Response to Reviewer #1

The authors investigated the future evolution of dense and deep-water formation in the Adriatic Sea, as well as its further spread and accumulation at different locations in the sub-basin, following the pseudo global warming (PGW) approach under the RCP8.5 emissions scenario. For this purpose, the authors use kilometer-scale simulations performed with the Adriatic Sea and Coast (AdriSC) climate model. The AdriSC model has already been evaluated in previous work. By the end of the century, the authors find a NaddW formation similar to the present climate, while the AdDW formation is expected to decrease. The authors report some new findings that make the article very interesting. Indeed, the evolution and mechanism of deep-water formation is a central topic in oceanography, especially in the Mediterranean Sea. Its future changes could have implications for regional circulation, biogeochemistry and marine ecosystems. In my opinion, the main novelty of this work is that the authors have examined the future effects on the dynamics of the NaddW and the AdDW separately, thanks to the use of kilometer-scale simulations.

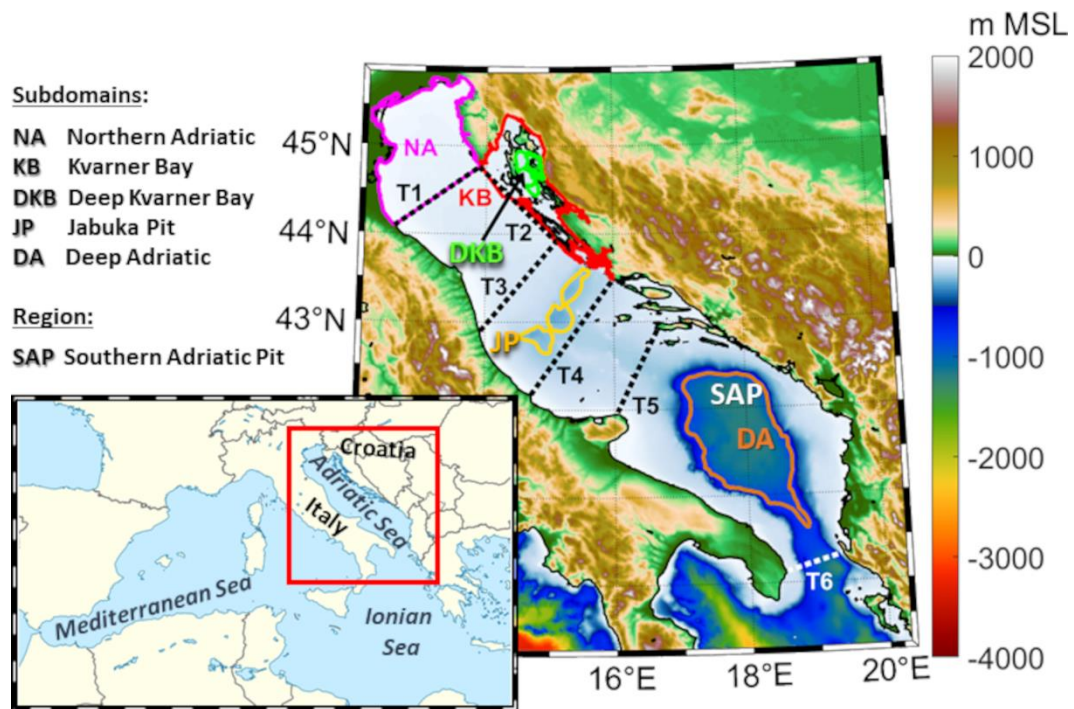
2) Regarding Figure 1, what criteria do you use to define the 5 subdomains (coloured polygons)? It should be stated somewhere in the text. Perhaps you could change the colour of the DKB polygon as it is quite similar to the colour used in NA. Could you include the meaning of MSL in the caption? The acronym MSL is not defined anywhere in the text.

Secondly, the color of the DKB subdomain is changed in order to have more contrasts with the other subdomains in the northern Adriatic. See figure below:

Finally, the meaning of MSL is added in the caption of Figure 1. See new caption below:

“Figure 1. Topo-bathymetry of the AdriSC climate model with the locations of the 5 subdomains (coloured polygons) and 6 transects (dotted black and white lines) used in the study. MSL stands for Mean Sea Level.”

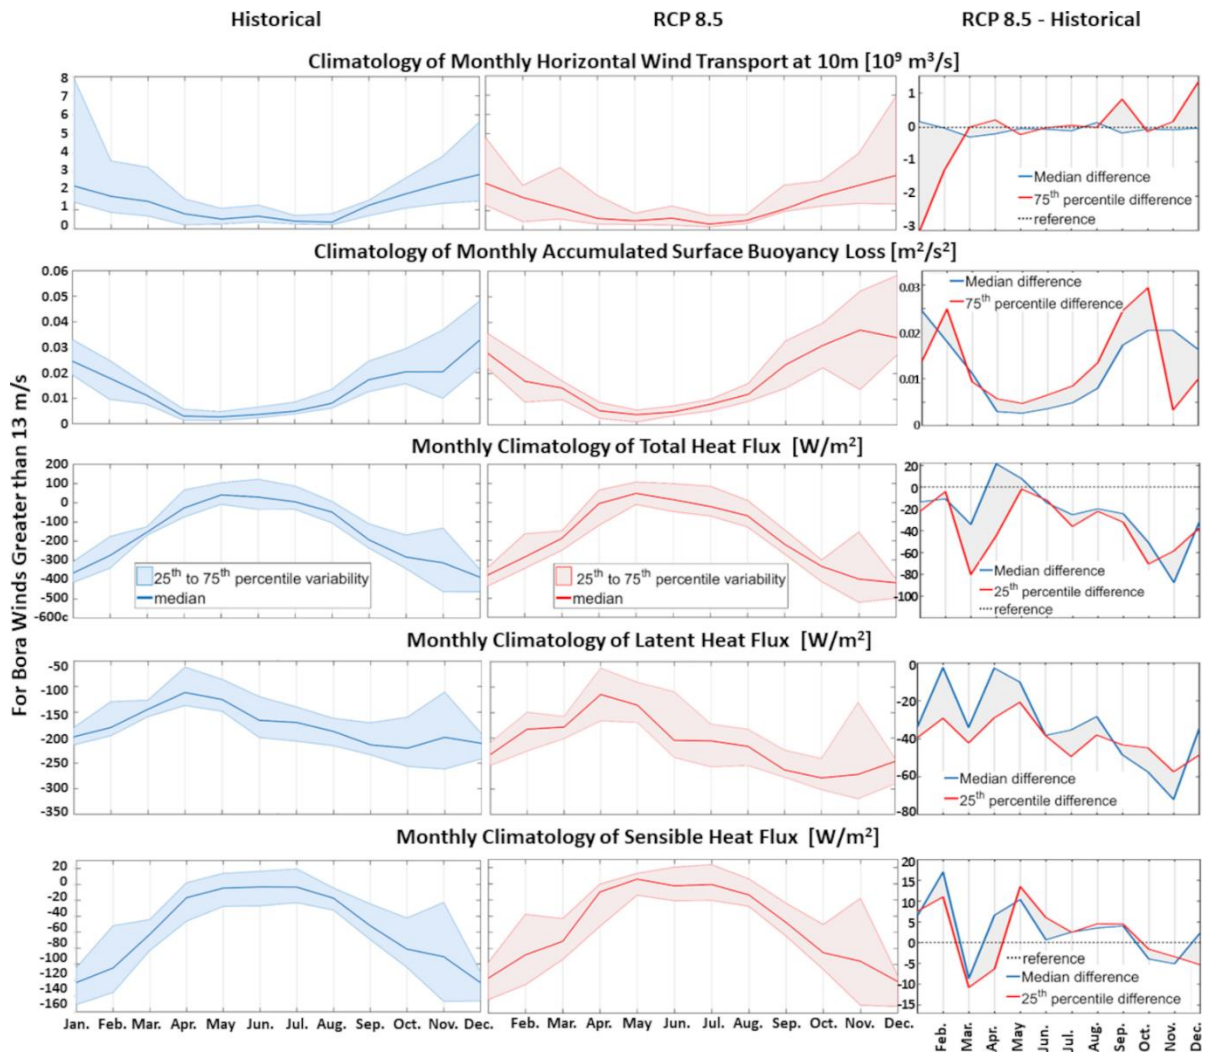
3) *One of my main concerns is that throughout the manuscript the authors give values for the differences between the RCP85 and historical periods. However, in most cases these differences are not easy to visualize in the figures because the authors show the historical and RCP8.5 periods separately. I strongly recommend that Figures 6, 7, 10, 11, 12 be redesigned to include a third column with the differences, or that both periods be combined in one column and the differences added in a second column. This would make the manuscript easier to follow.*

- Lines 212-217: This paragraph is hard to follow. In the text, the horizontal wind transport ranges from 20 to 2800×10^9 m^3/s , while in Figure 6 it ranges from 0 to 8 [10^9 m^3/s]. Please clarify the order of magnitude used.

Answer: the authors fully agree with the reviewer and have updated all the climatological figures with a third column showing the differences between RCP 8.5 and historical conditions for the median and the extreme value (25th or 75th percentile depending on the sign of the studied variable). See new figures below:

Answer: thanks a lot for spotting the mistake. The paragraph is rewritten as follows: “For both historical and RCP 8.5 simulations, the strongest horizontal wind transports (median value above 2.8×10^9 m^3/s) occur between November and March. Compared to the historical results, the horizontal wind transports are overall reduced in the RCP 8.5

simulation – i.e., between $0.02 \times 10^9 \text{ m}^3/\text{s}$ in February and $0.28 \times 10^9 \text{ m}^3/\text{s}$ in March – but increased in January and August by about $0.17 \times 10^9 \text{ m}^3/\text{s}$ and $0.14 \times 10^9 \text{ m}^3/\text{s}$, respectively. In terms of the most extreme wind transports, defined as the 75th percentile, they are reduced in the RCP 8.5 simulation by up to $3.07 \times 10^9 \text{ m}^3/\text{s}$ in January and $1.25 \times 10^9 \text{ m}^3/\text{s}$ in February but are increased by up to $0.82 \times 10^9 \text{ m}^3/\text{s}$ in September and $1.33 \times 10^9 \text{ m}^3/\text{s}$ in December.”

Figure 12. Daily climatologies of the median, 25th and 75th percentiles of the dense water transport defined along the T1 to T5 transects for the 31 years of the historical, RCP 8.5 and RCP 8.5 minus historical conditions.

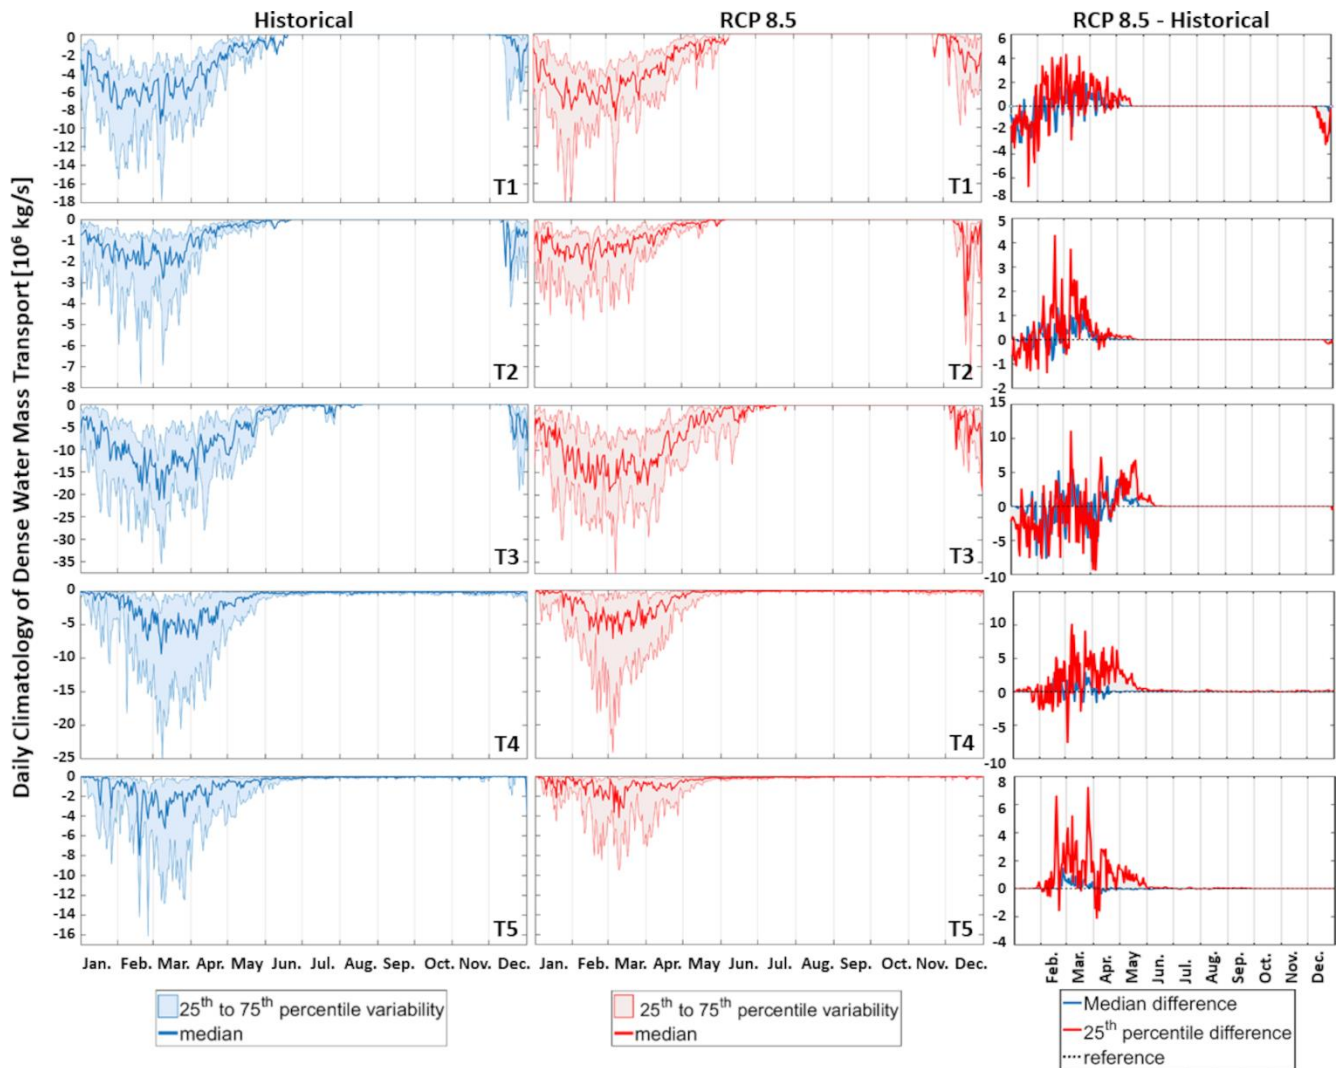
- L345-346: “(i.e., shift in peak reduction in dense water transports between T3 and T4; Fig. 12)” *I do not fully understand what the authors*

Answer: The sentence is changed as follows: “(i.e., the maximum reduction in dense water transports between T3 and T4 which frame the JP is obtained in March under the historical conditions and in December under the RCP 8.5 conditions; Fig. 12)”

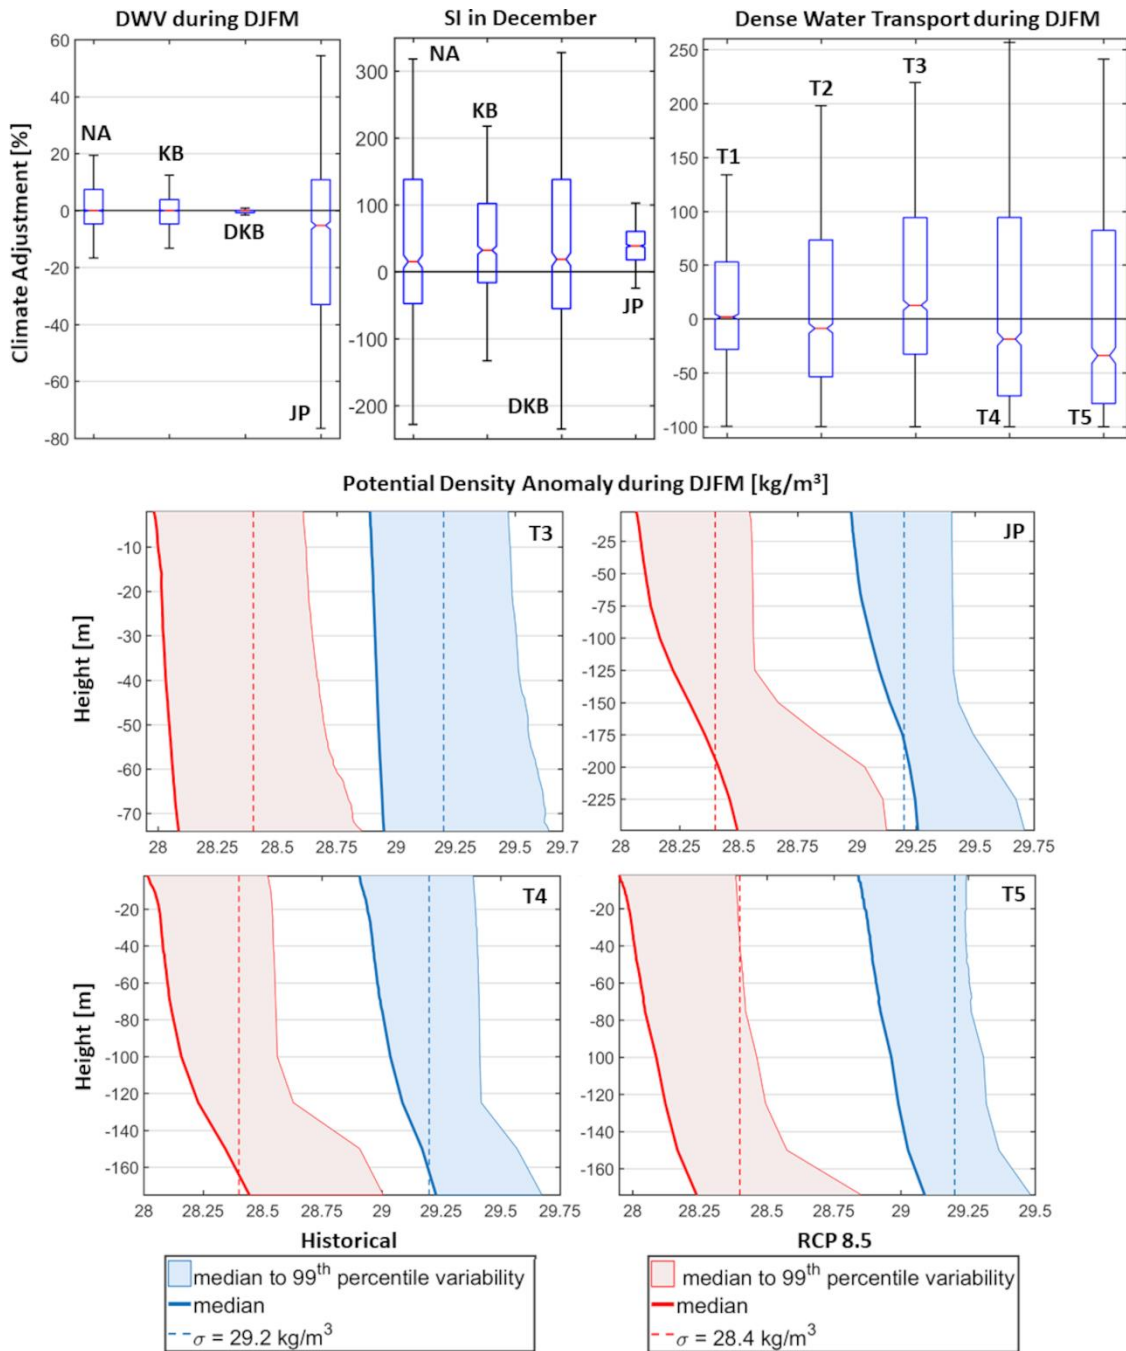
5) In Figure 13, the SI appears to be calculated for the DJFM period. This is strange if the aim is to estimate the resistance of the water column to convection. Please consider computing it for a period before convection (for example in December or in autumn).

Answer: the SI is recalculated in December identically to Parras-Berrocal (2023). See figure new below:

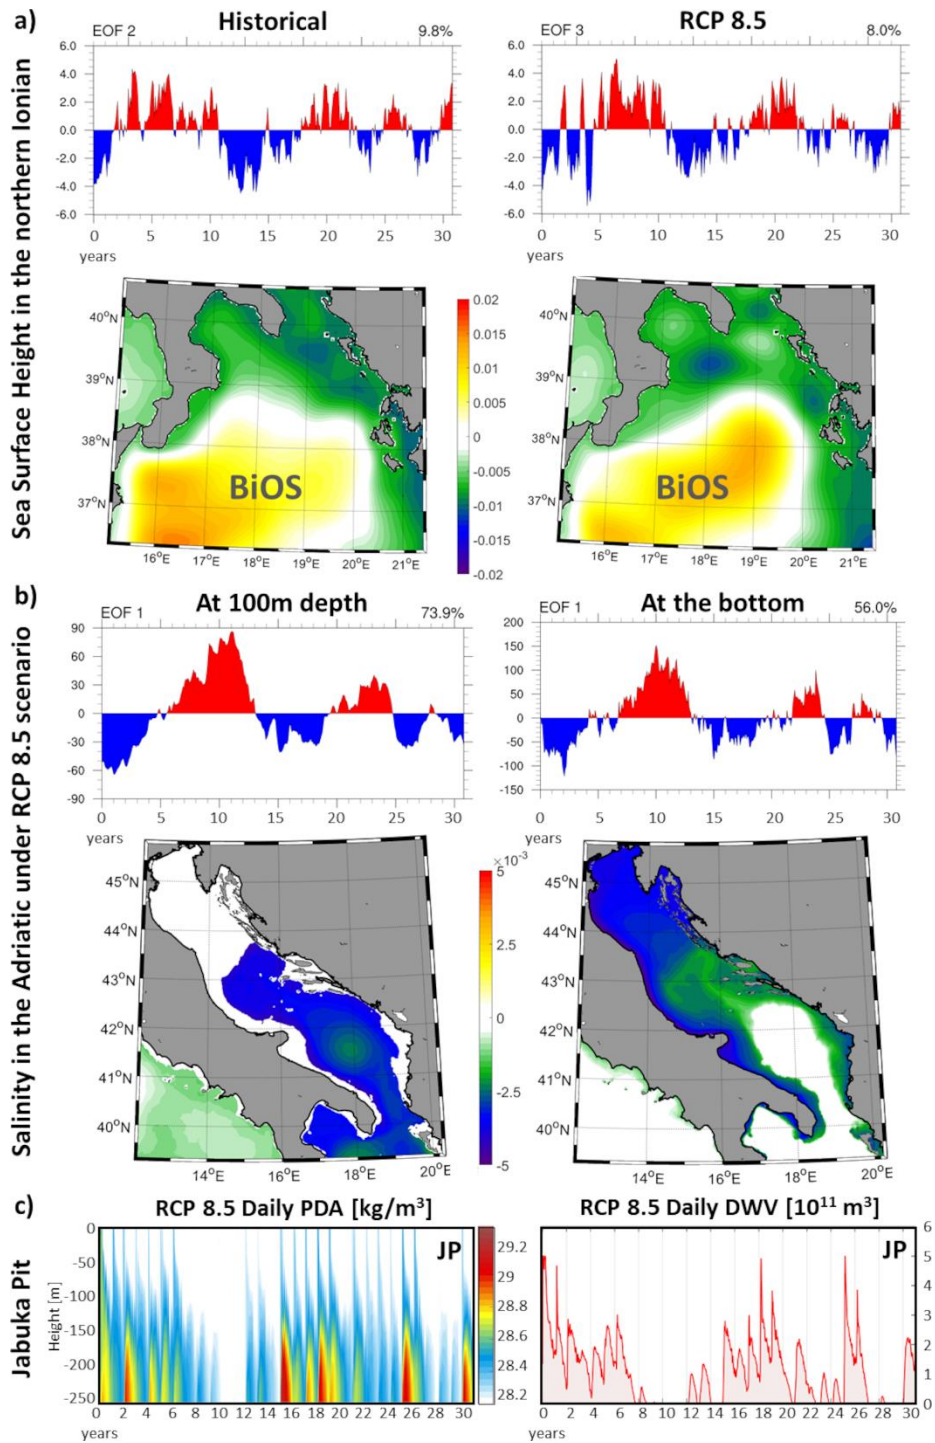
6) Please add letters to the figure panels at least in Figures 14 and 15. This will make the text easier to read and understand. Captions should be rewritten accordingly.

Answer: the letters (a to d) are added to Figures 14 and 15 and the captions are changed. See new figures and captions below:

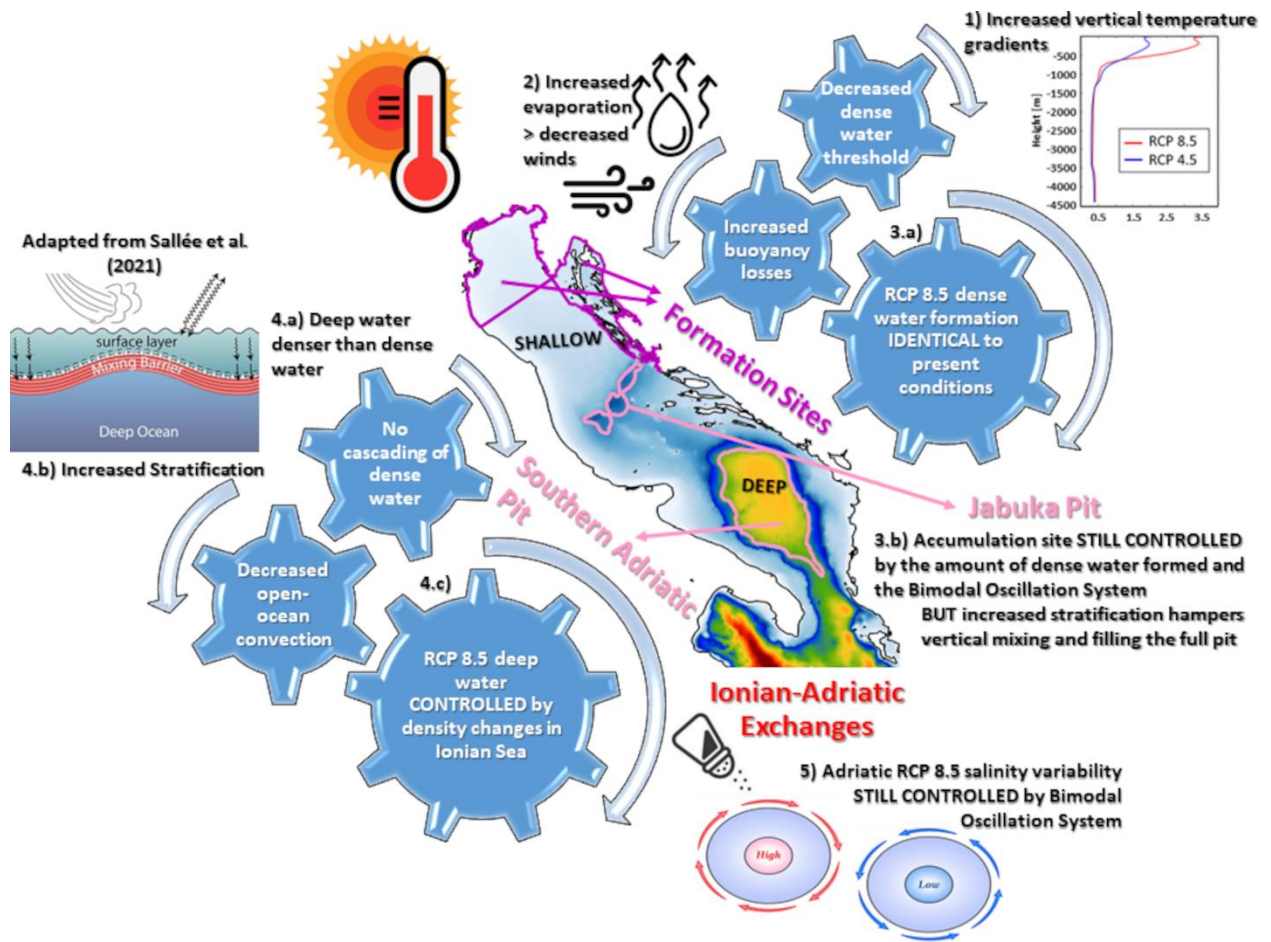
7) Figure 16 is not easy to understand on its own. I would recommend following the numerical order used in the conclusions section to reorganize the figure, giving the same number to the processes involved in each conclusion. Otherwise, I would recommend removing Figure 16.

Answer: the authors believe that Figure 16 is important as a visual summary of the study and are keeping it. However, in order to facilitate the understanding of the figure, numbers and letters are added to the figure and the following sentence is added to the caption: "The numbers and letters correspond to the description of the different findings as described in the conclusions." See new figure and caption below:

Figure 4. Historical monthly climatology of the spatial extent, intensity and direction (as vectors) of the selected windstorms (≥ 13 m/s) defined as the monthly median wind speed at 10 m over the 31 years of the historical simulation.

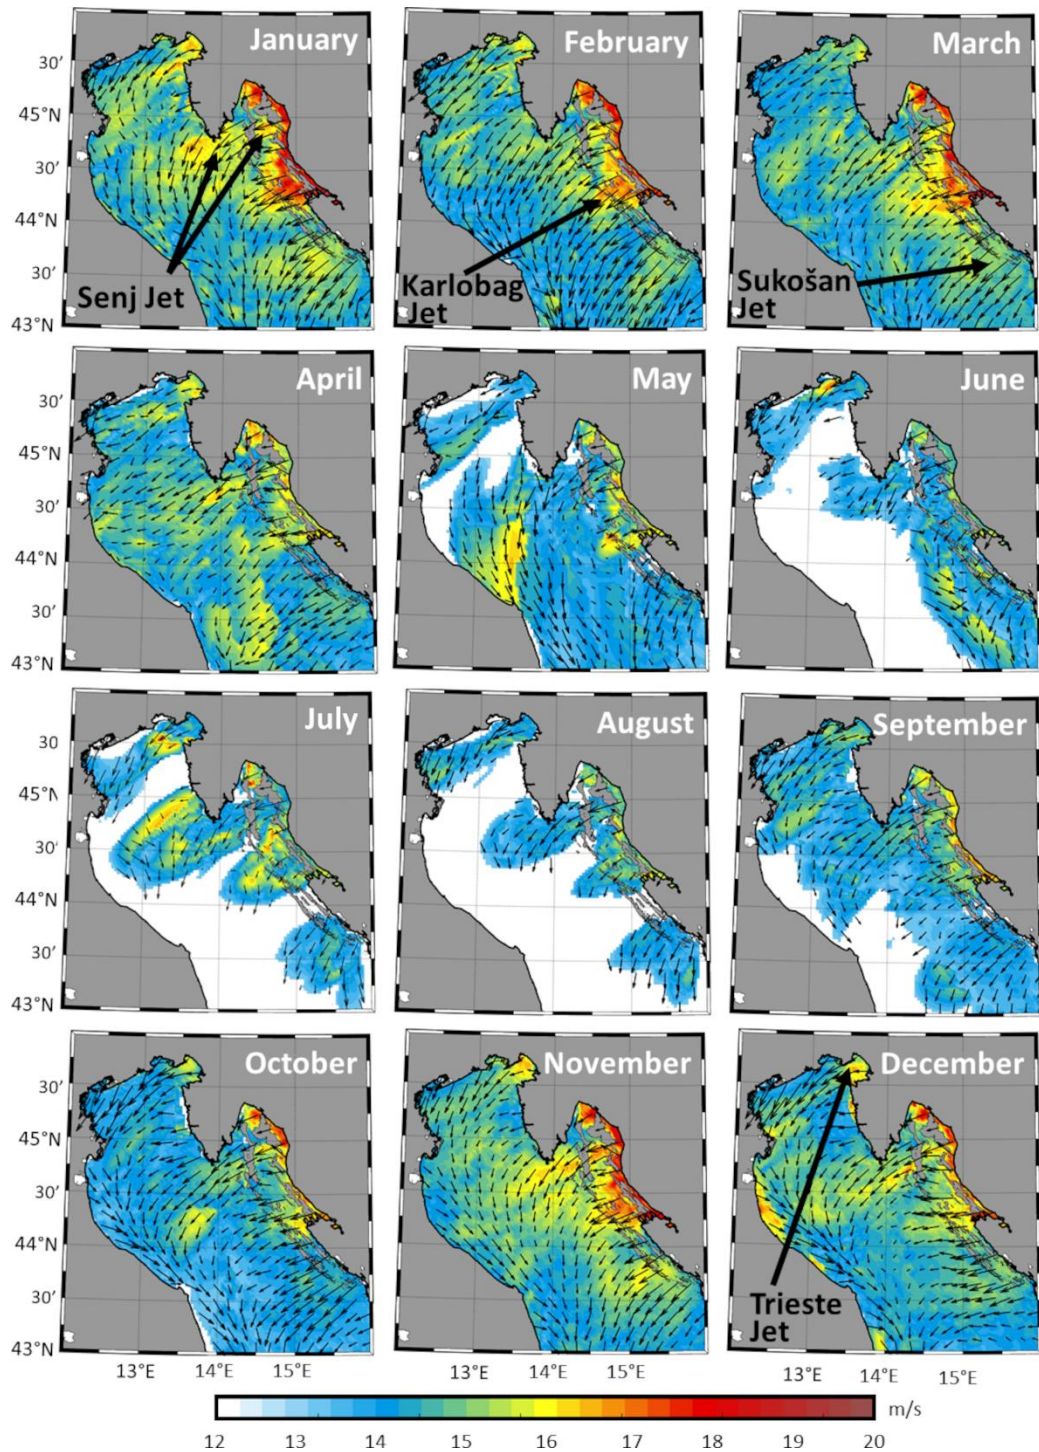
- *Figure 4: I would suggest including the vector field.*

Answer: the wind vector field is added to figure 4. See below new figure.
